18 January 2012

## **Response to RMA section 92 request for further information from West Coast Regional Council**

## **Response to RMA section 92 request for further information from Westland District Council**

*Photograph 3* near Hans Bay Boat Ramp shows the lake level at - 0.1m or 1.1m below the crest of the weir. This water level is within the consented minimum (which is -0.2m, or 1.2m below the crest of the weir).

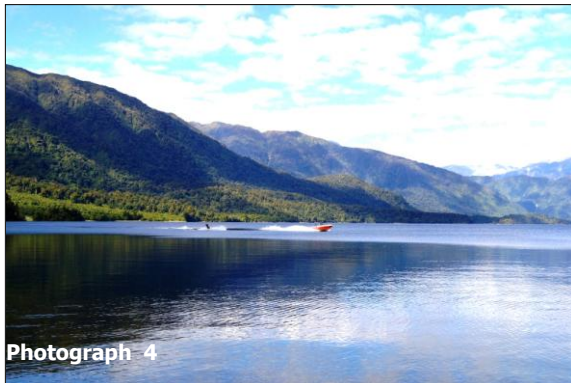
## Assessment of the effects of the lakes altered state relative to criterion (a) above

As outlined above, the main difference between the existing and proposed operating regimes is that the lake level will overall be lower for slightly longer periods under the proposed regime than it is at present. In visual and landscape terms this means the gravel and sand around the edge of the lake will be exposed for slightly longer periods.
